# UNITED STATES PATENT AND TRADEMARK OFFICE

APPLICATION NO.	FILING DATE	FIRST NAMED INVENTOR	ATTORNEY DOCKET NO.	CONFIRMATION NO.
09/209,751	12/11/1998	TORU MATAMA	1110-0212P	6573

## Office Action Summary

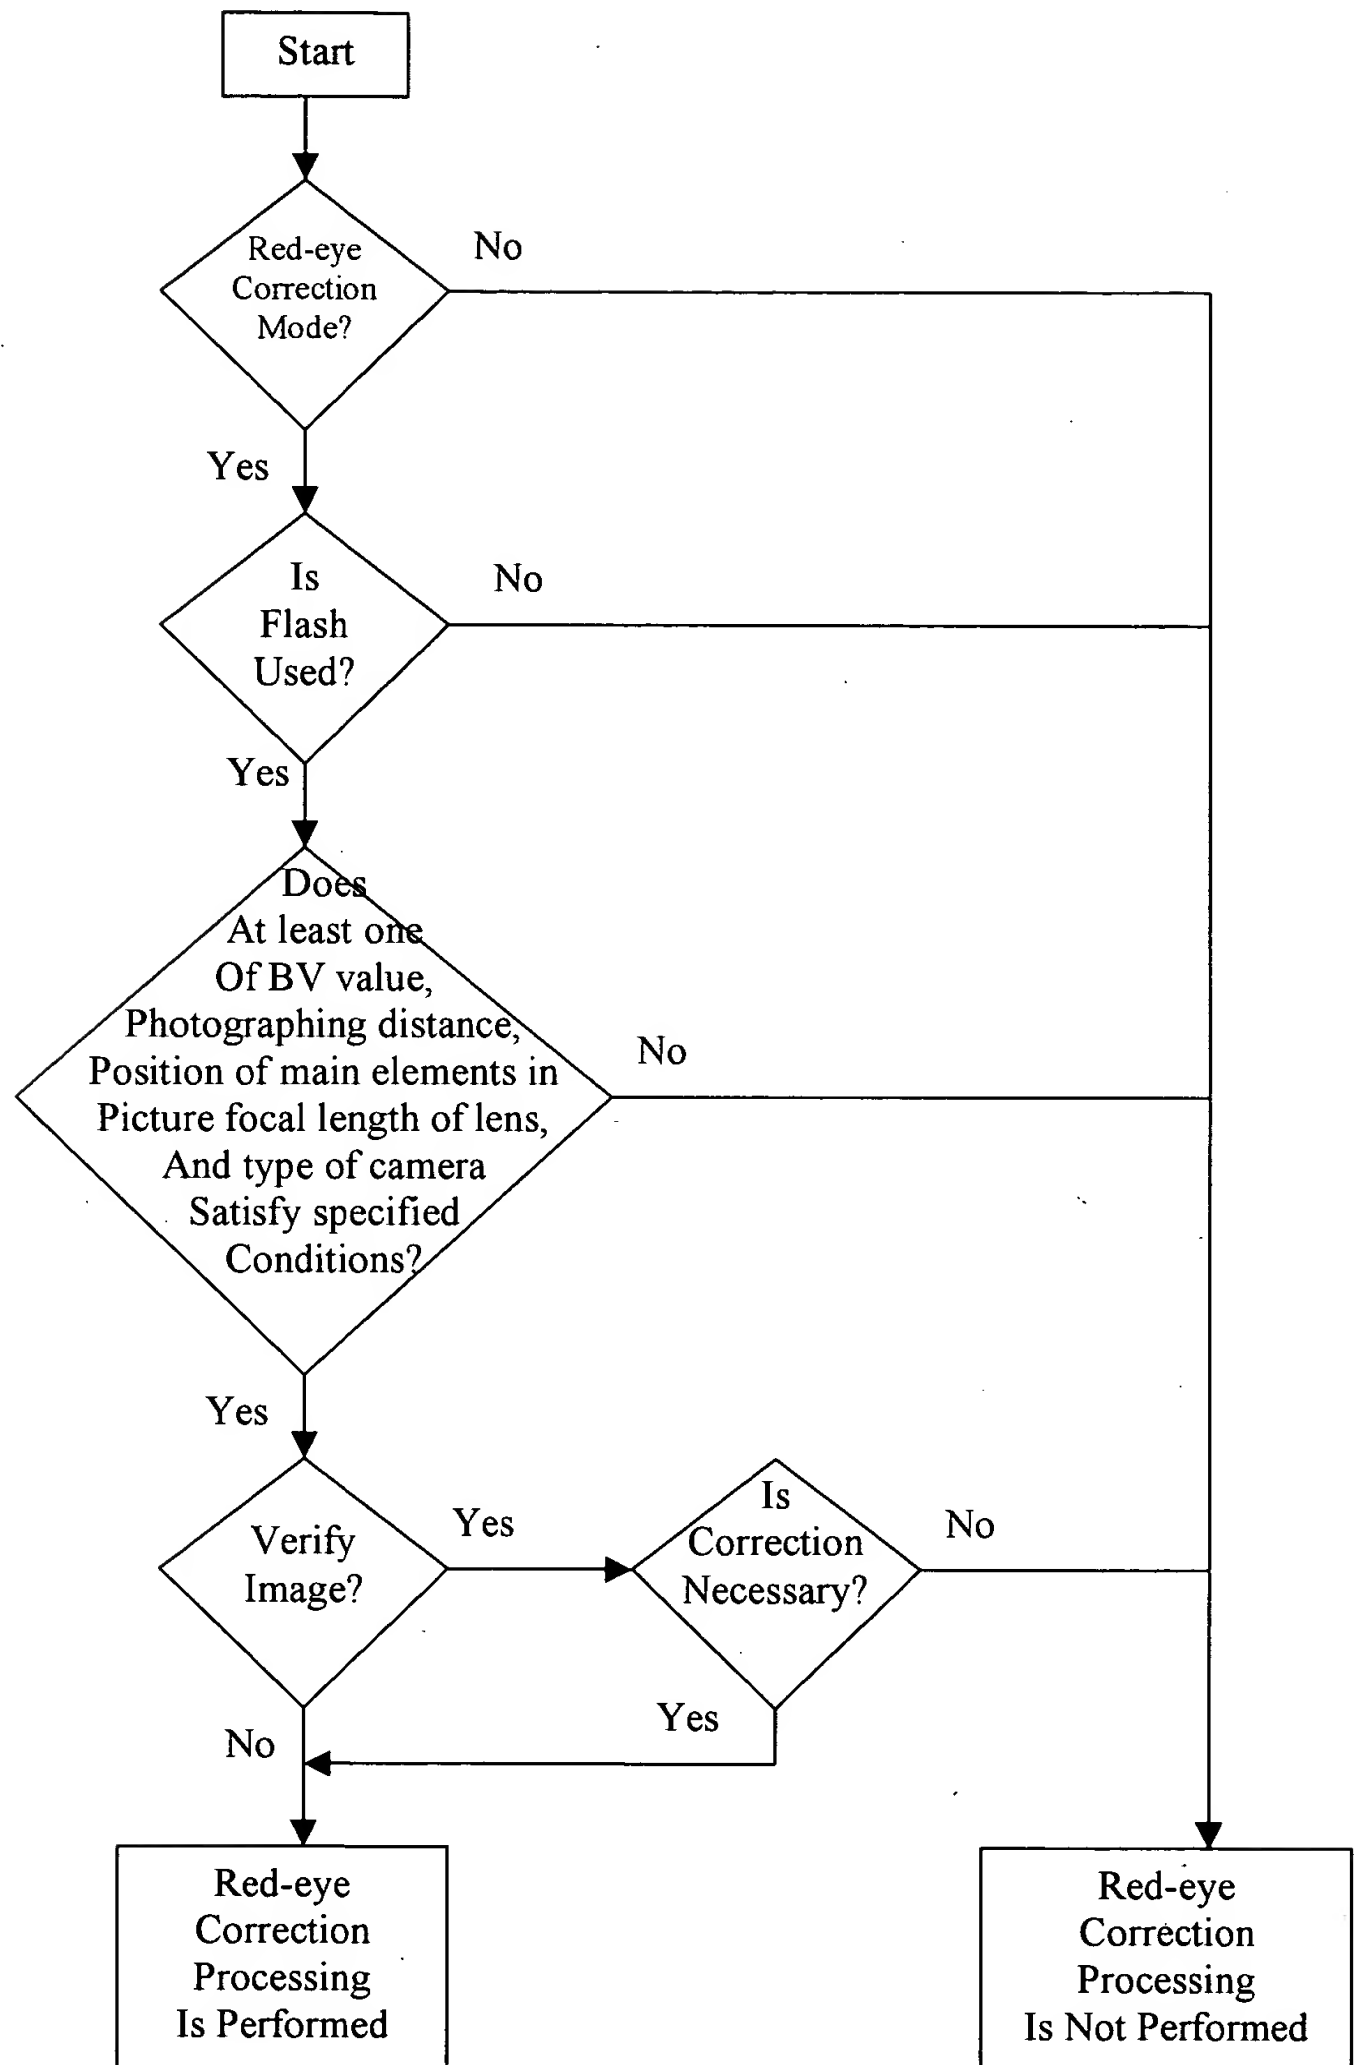
The last paragraph of page 12 is new matter corresponding to the branch of the flow diagram of newly added Fig. 3 leading to step S110 which is also new matter.

The addition of elements 78 and 56 to Fig. 2 are also new matter. Examiner notes on page 17, lines 4-8 of the specification as originally filed that when the red-eye processing is not performed it passes through the memory 56 to element 58. There is no disclosure of providing a bypass around the memory 56 as originally filed.

Examiner notes that the drawing objections were drawn to the limitations of claims 2-7 and 9 not being shown. Examiner agrees with the assertion that the limitations of claims 6, 7, and 9 were previously illustrated through Fig. 2. Examiner thanks applicant for adding Fig. 3 so as to show the limitations of claims 3-5 and a portion of claim 2. Examiner also thanks applicant for their effort in modifying Fig. 2 so as to show the other portion of the limitations of claim 2.

Examiner notes that the limitations of claim 2-5 are supported in the specification as originally filed on page 26, line 11 – page 27, line 7 wherein it is described that a means for selecting either one of execution and non-execution of processing as a mode is where a user can verify an image to determine if red eye correction processing is needed or where no verification or red eye processing is performed. On page 30, lines 11-15 it is described that either one of execution and non-execution of processing is selected as a mode. Finally on page 31, line 13 – page 32, line 11 it is described that either one of execution and non-execution of processing is determined automatically from photographing information.

As such, in order to overcome the drawing objections Examiner suggests modifying Fig. 3 as illustrated below corresponding to the disclosure of the specification as originally filed:

The drawings are objected to under 37 CFR 1.83(a). The drawings must show every feature of the invention specified in the claims. Therefore, the limitations of claim 2 must be shown or the feature(s) canceled from the claim(s). No new matter should be entered.
